## HISTORIC AND DESIGN REVIEW COMMISSION

**HDRC CASE NO:** 2018-236  
**ADDRESS:** 108 N MEDINA  
**LEGAL DESCRIPTION:** NCB 264 BLK 76 N 69.05 FT OF S 133.45 FT OF 9 ARB A9  
**ZONING:** D, HE  
**CITY COUNCIL DIST.:** 5  
**DISTRICT:** Cattleman Square Historic District  
**LANDMARK:** I&GN Depot Cluster  
**APPLICANT:** John Speegle/SKDA  
**OWNER:** North Medina LLC  
**APPLICATION RECEIVED:** May 11, 2018  
**60-DAY REVIEW:** July 12, 2018

## **Applicant's Project: Santa Monica Hotel Elevator & Stairs Addition**

Street View - Jan 2017

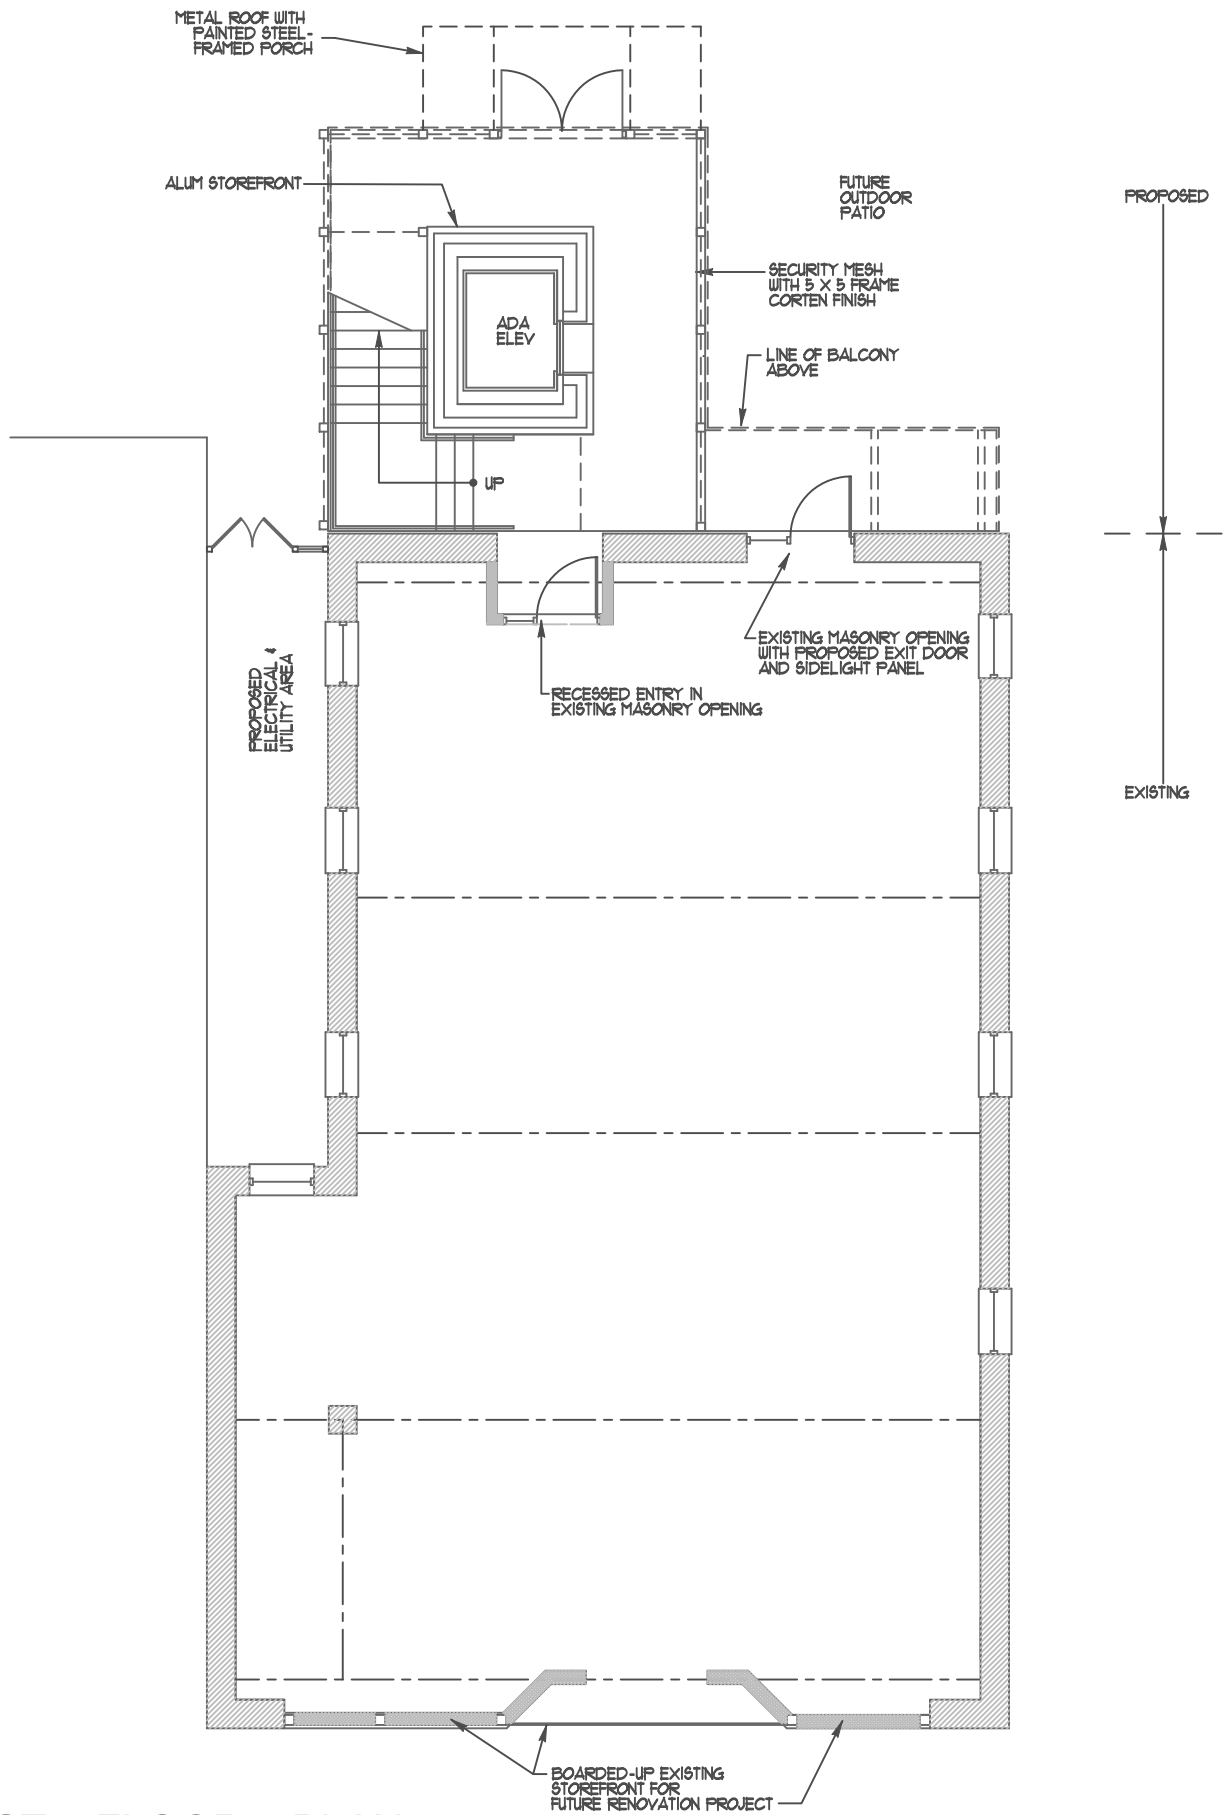
- c. **BRICK RESTORATION** – The applicant has noted that re-pointing of the existing brick with a grout color to match that found historically on the structure will occur. This is consistent with the Guidelines for Exterior Maintenance and Alterations 2.B.ii.

## EAST ELEVATION

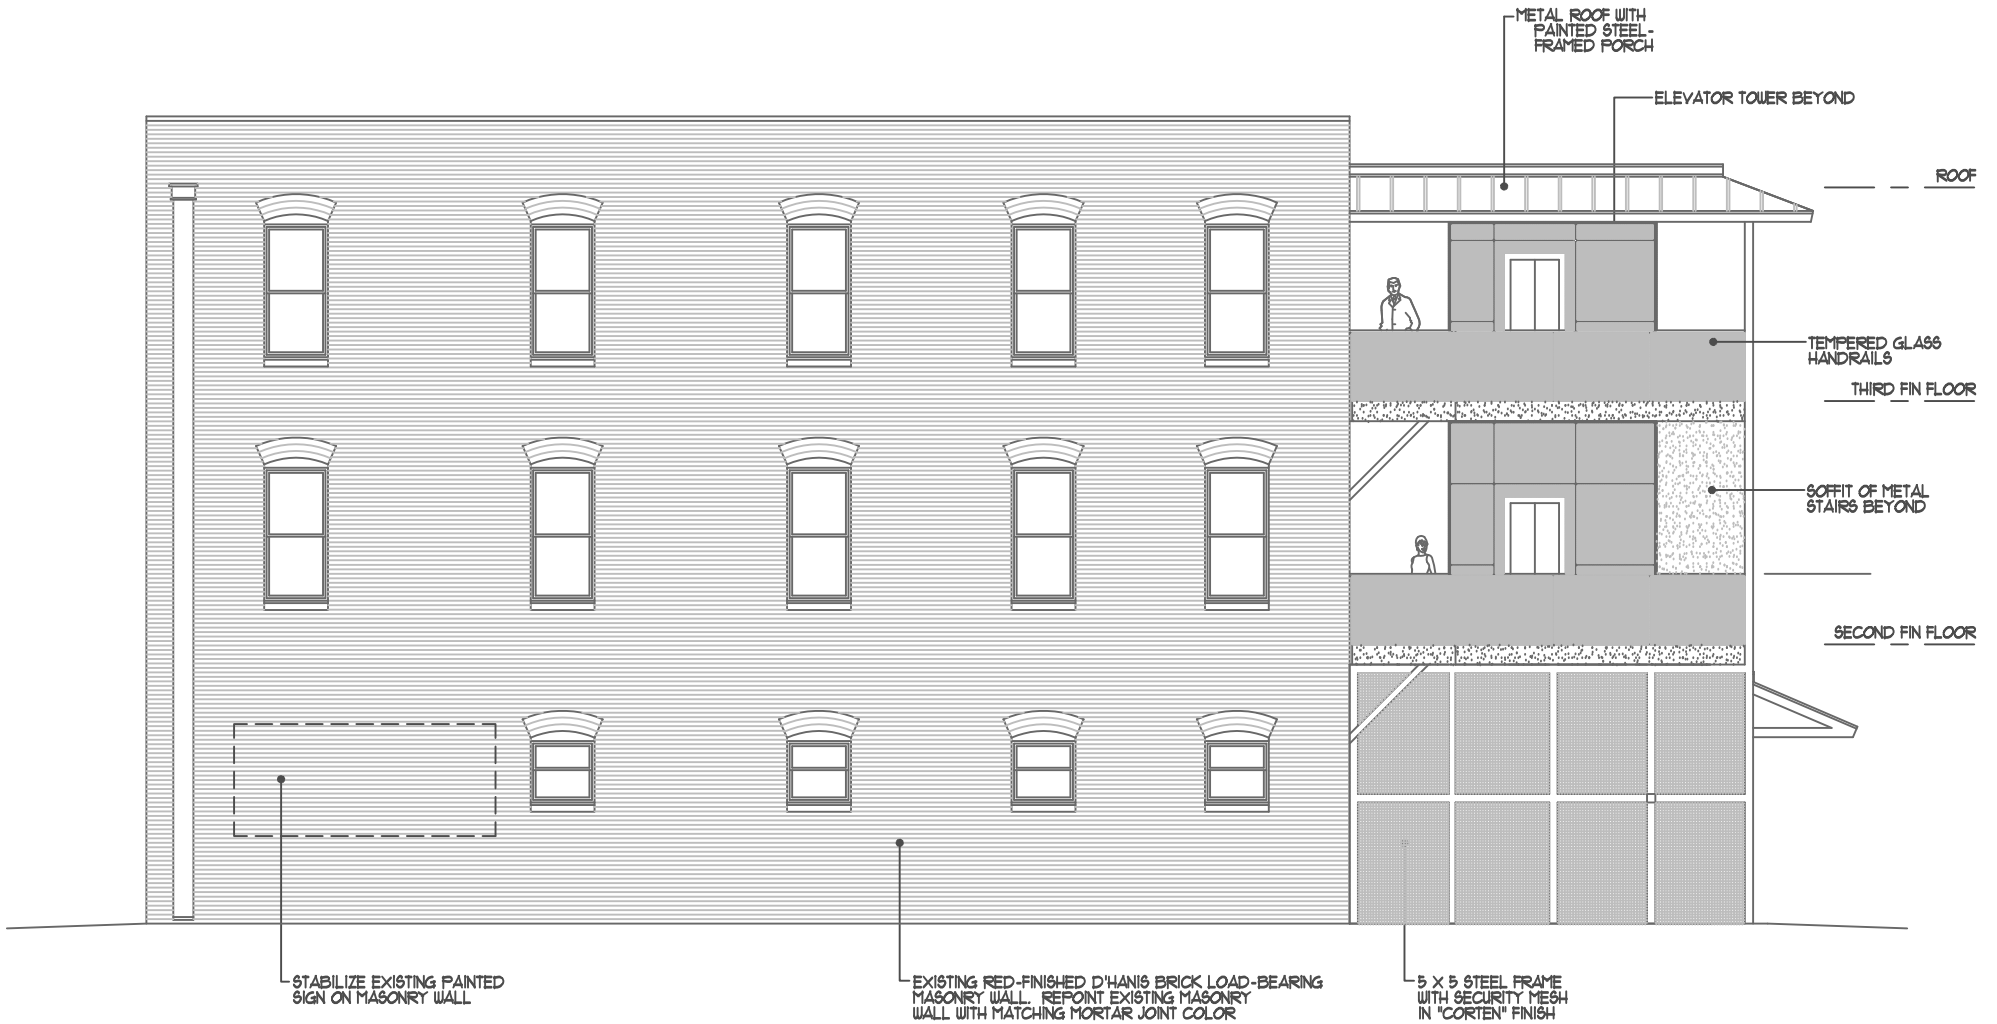
- d. **ELEVATOR ADDITION** – At the rear of the historic structure, the applicant has proposed to construct an elevator and stair tower addition. Per the Guidelines for Additions 2.A., new additions should be designed to be in keeping with the existing, historic context of the block, should be located at the side or rear of the historic structure, should feature a similar roof form, should be subordinate to the principal façade and should feature a transition between the old and new. The proposed addition is consistent with the Guidelines.

- e. **SCALE, MASSING & HEIGHT** – The applicant has proposed an overall height, massing and footprint that are subordinate to that of the primary historic structure. This is consistent with the Guidelines.

- g. **ROOF FORM** – The applicant has proposed for the tower addition to feature a hipped roof and a shed porch roof at the first floor. Both of these forms are found historically in the district.

- h. **BALCONIES** – In addition to the proposed elevator and stair tower addition, the applicant has proposed to construct balconies at each level on the rear façade. The balconies will provide a secondary means of egress. Generally, staff finds the proposed balconies to be appropriate. Historically, commercial brick structures such as this would have featured a rear balcony. The applicant has noted the installation of egress doors in existing, rear window openings. When returning for final approval the applicant should submit a detailed elevation of the proposed door profile.

- i. That the standing seam metal roofs feature panels that are 18 to 21 inches in width, seams that are 1 to 2 inches in height, a crimped ridge seam and a standard galvalume finish.
- ii. That when submitting for final approval the applicant submit details that include balcony details, egress door elevations, tempered glass handrail details and additional information regarding materials including a material sheet.
